BASIC PERMIT PACKAGE **REVIEWED FOR CODE COMPLIANCE** WITH IRC 2015 KITSAP COUNTY BUILDING DEPARTMENT

Established Basic Permit # 19-03646

Permit Number: 20-04894

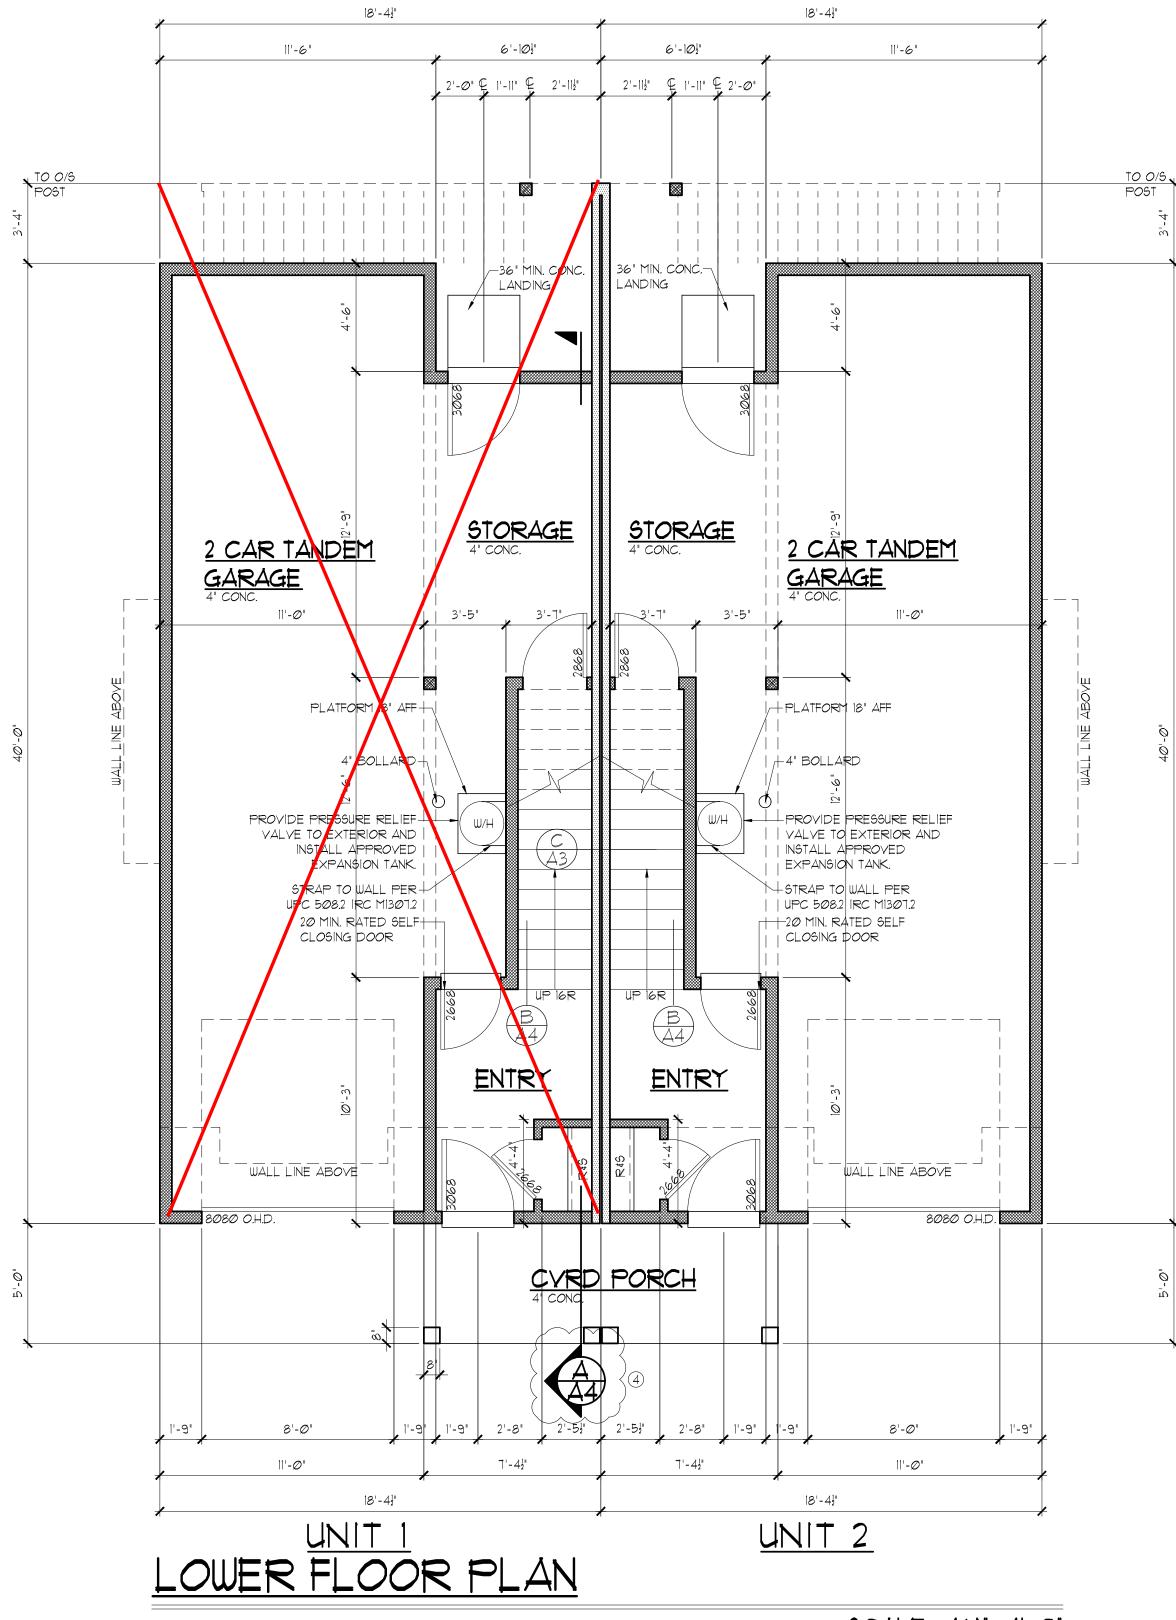
Basic plans are approved with a Geotechnical report for two parcels only: Tax Account Number 152501-3-095-2009 Tax Account Number 152501-3-096-208

$\overset{}{\longrightarrow}$ Blower Door Test required by Final Inspection as per WSEC R402.4.1.2 mmm

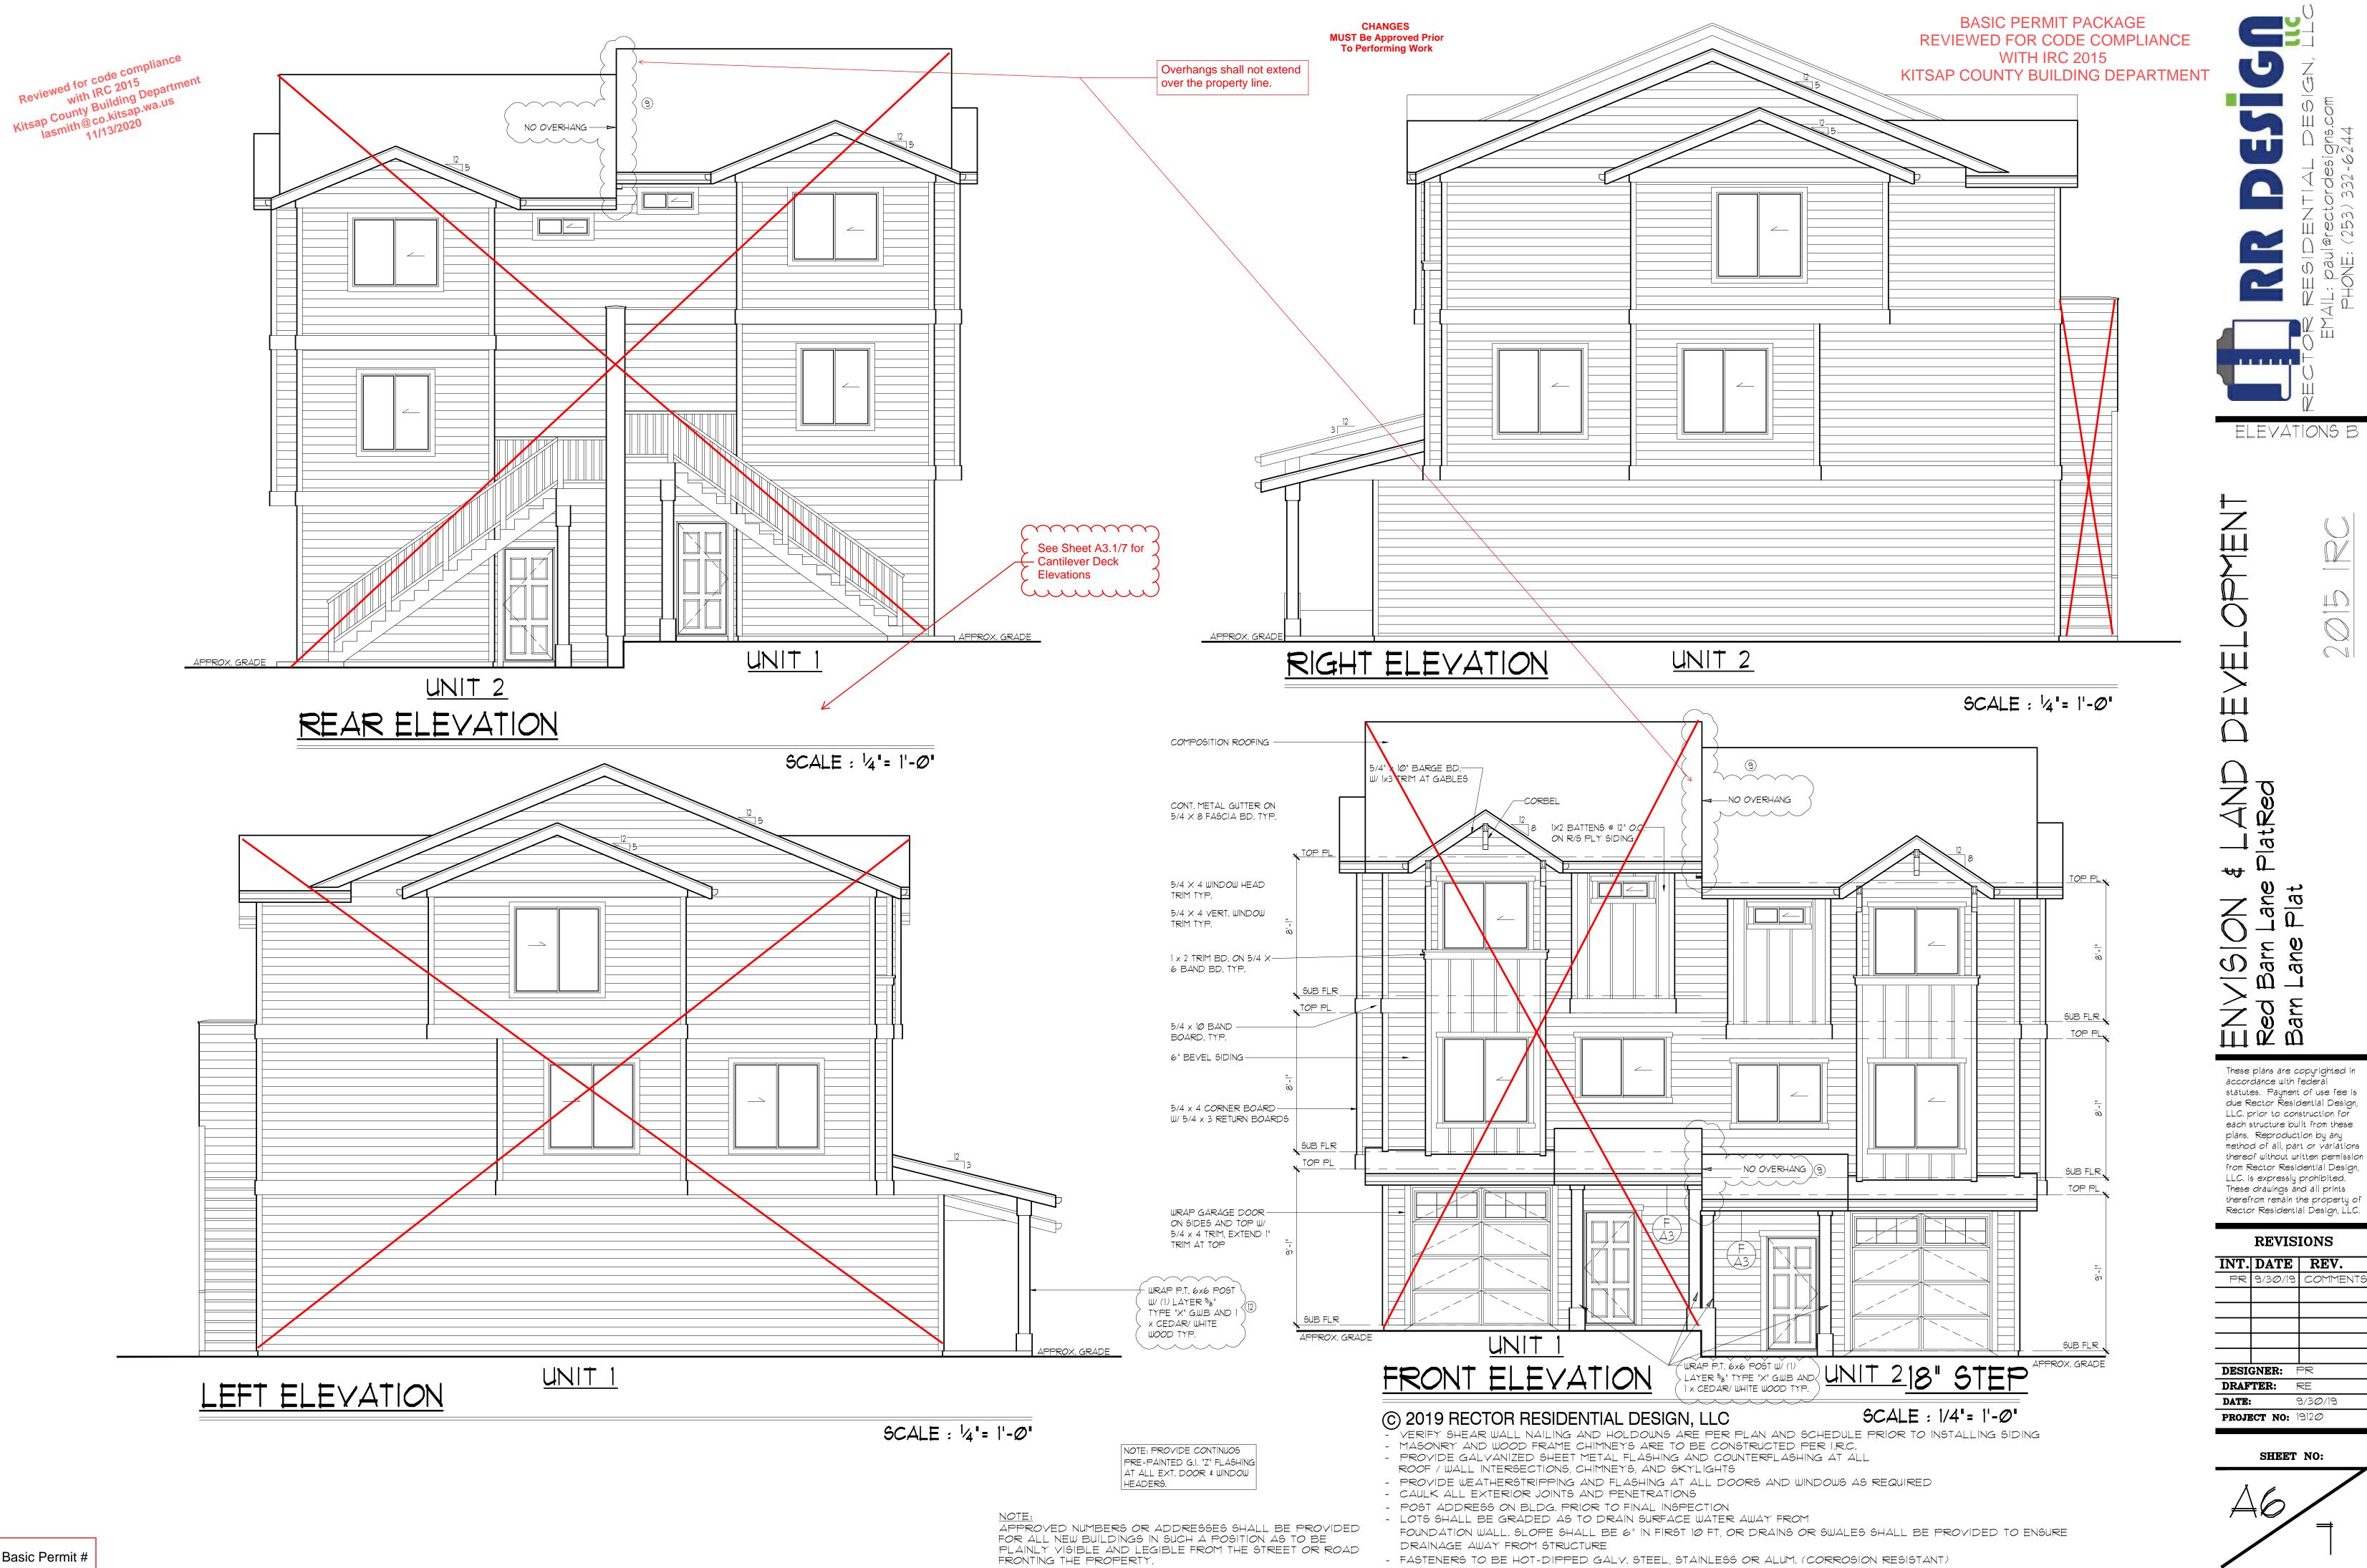
Whole House fan to have be a

(See Energy Code Worksheet).

45cfm fan with a continuous runtime
